Dublin Cycling Campaign,
% Tailor's Hall,
Back Lane,
Dublin 8

COOLMINE-PORTERSTOWN-CLONSILLA-BARBERSTOWN-BLAKESTOWN

21 October 2020

Figure ES-11 Coolmine Option 3 - Emerging Preferred Option Coolmine Level Crossing Replacement

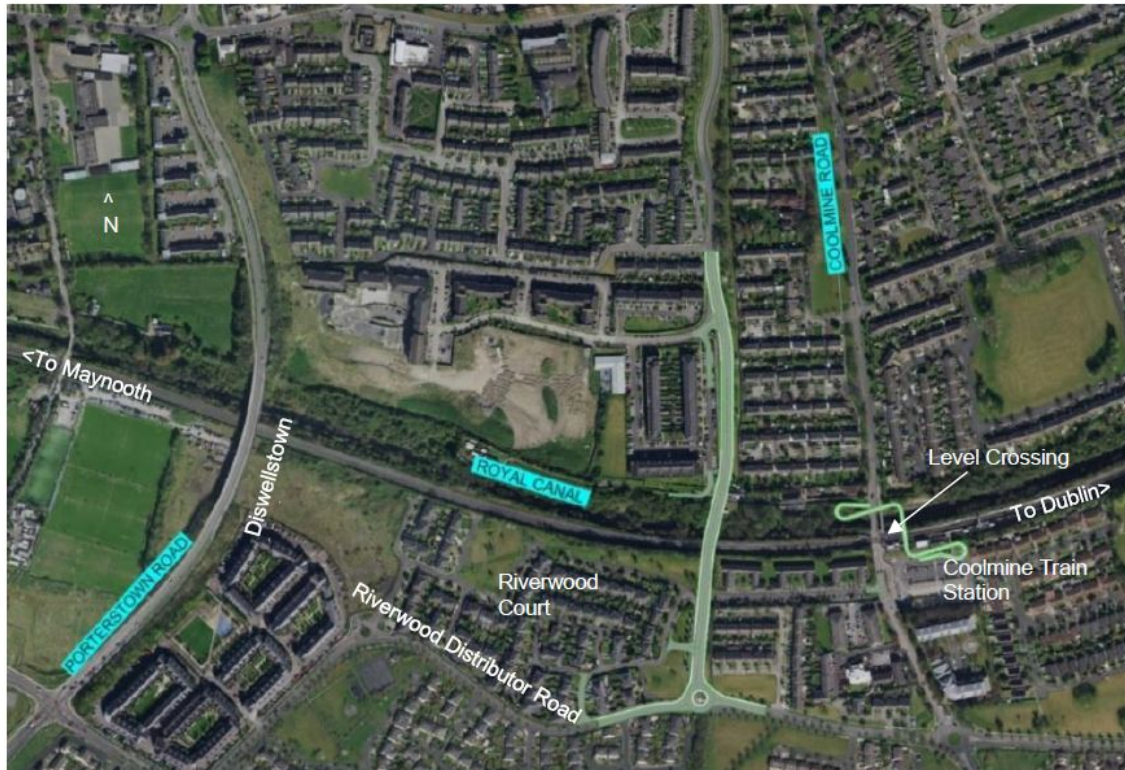
- Will there be cycle paths provided on the overbridge on Option 3?
- Concerns about the entrance to cycle and pedestrian bridge through Coolmine car park. No connectivity and will put people who cycle and pedestrians at risk from conflict with car drivers and walkers commuting across the car park. The car park will need to be redesigned to cater for all modes of transport. This is one of the “5 needs” of design needs for cyclists referenced in the National Cycle Manual. <https://www.cyclemanual.ie/manual/thebasics/fiveneeds/>

- Will the new pedestrian and cycle bridge connect to the Royal canal entrance? Space is limited and might put people in danger trying to join the royal canal from the new pedestrian and cycle bridge on the Northside of the royal canal as the entrance to the Royal canal is situated between Sheepmore lane and the level crossing. Pedestrians and cyclists will have to walk back towards the level crossing to enter the royal canal towpath. How will this area be laid out when the level crossing is closed? Will it become a place for people to park their cars? Placemaking and well thought out design is required to make this location inviting also at night time to make entering the royal canal towpath safe and well lit up for walkers and people who cycle in the evening or commuting from employment for example.

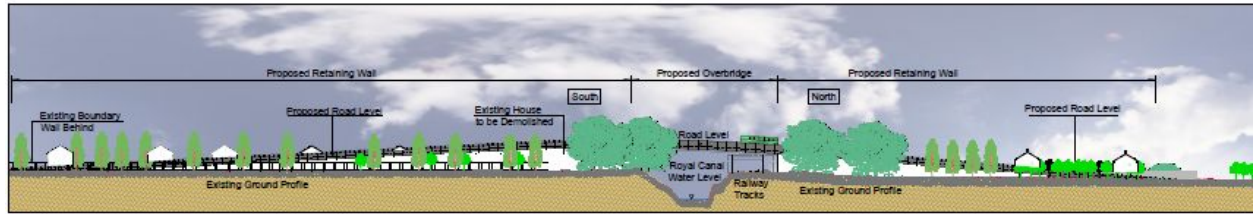
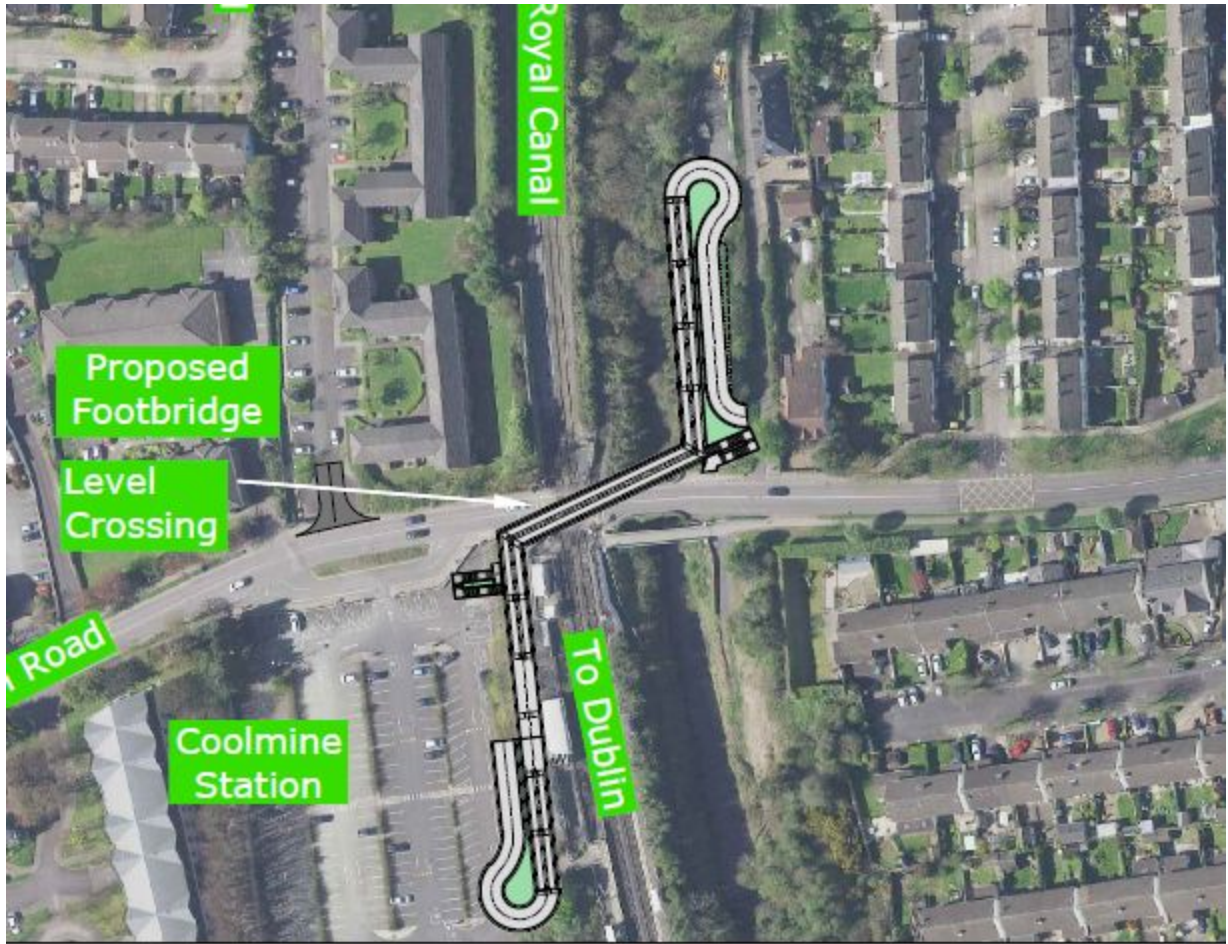
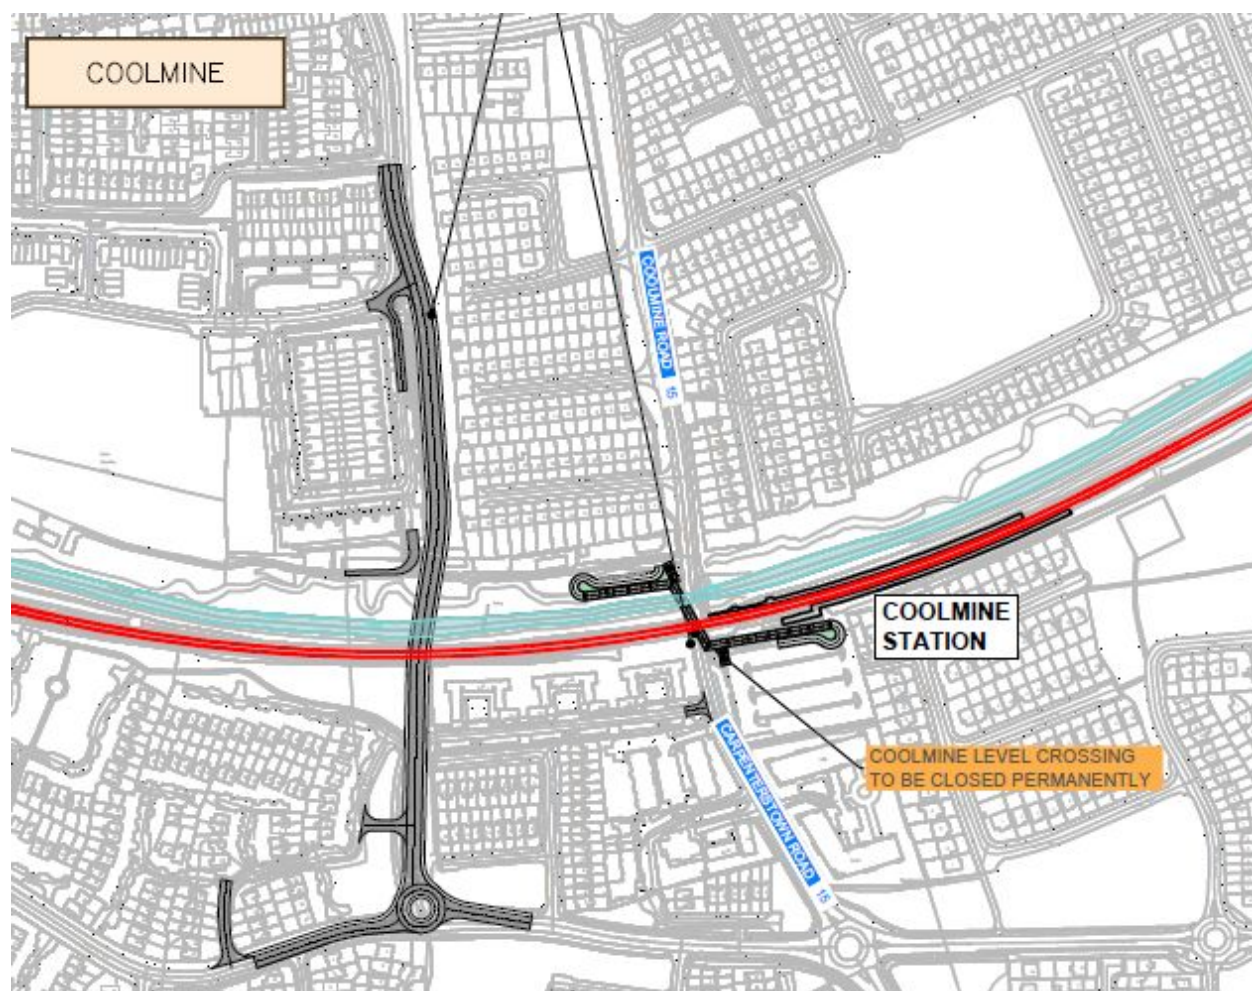
- In the preliminary option design selection Options 1, 3, 6 and 7 are given green to go ahead to Phase 2 although in the report you state that Options 1, 3, 4 and 6 are going to Phase 2? This doesn't make sense. Is there a mistake? Can you clarify this please? This means that Option 7 is being dropped which was given green according to the MCA criteria and Option 4 which was red is going instead to Phase 2? This is really important for people who cycle and walk as Option 7 is not being considered and it's a walking and cycling bridge. We have attached the preliminary options report below.

Figure 9-55 Barberstown Level Crossing Options (Copyright Ordnance Survey Ireland – 0039720)

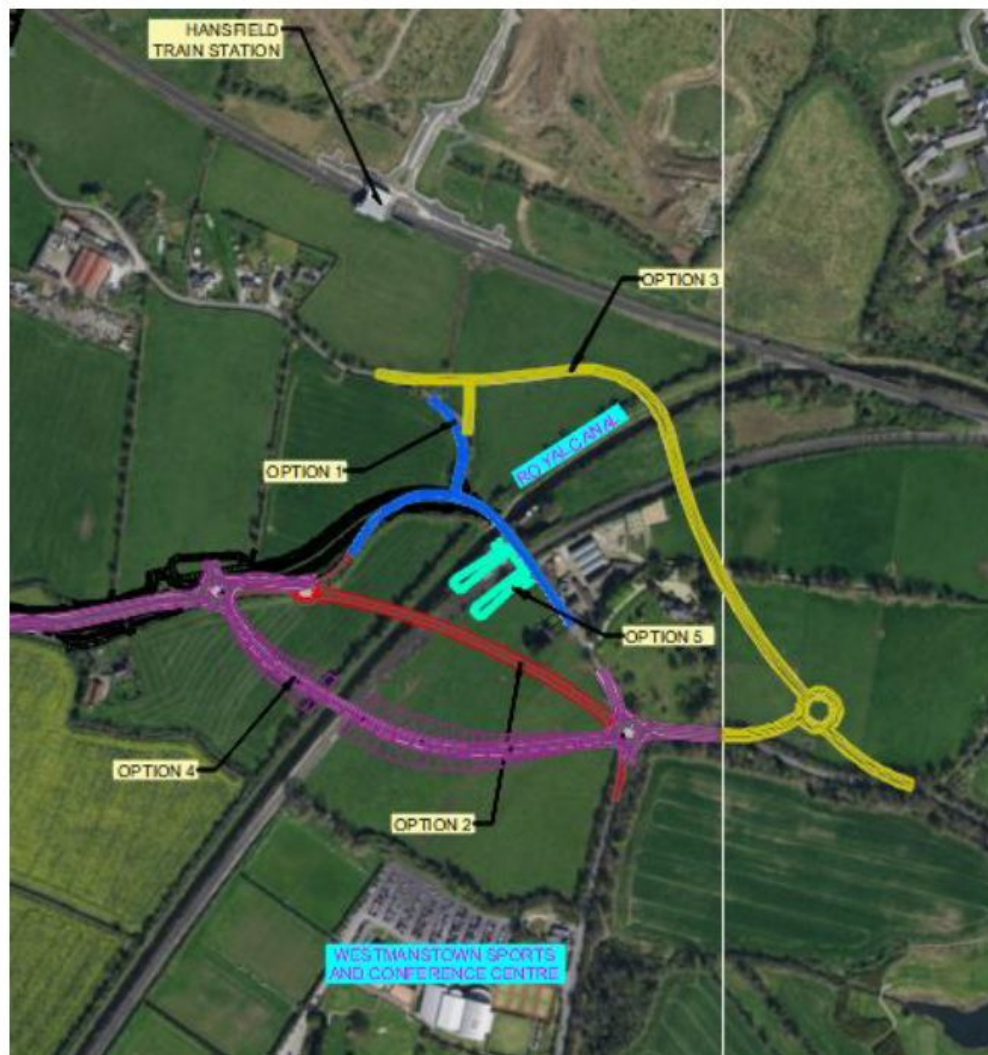
- It's concerning that there is no separate cycling and walking bridge for a location that has no developments and is not hindered by space constraints, although the current proposal for Kellystown Road would include a two-way cycle lane both could have two-cycle/pedestrian connections for local access.
- Are there separate cycle lanes and pedestrian paths in the Options 2 and 4 going to Phase 2?
- There is an opportunity to extend a bridge from Option 3 to connect to Hansfield train station to increase connectivity in this area and also Westmanstown golf club and the Liffey Valley region.
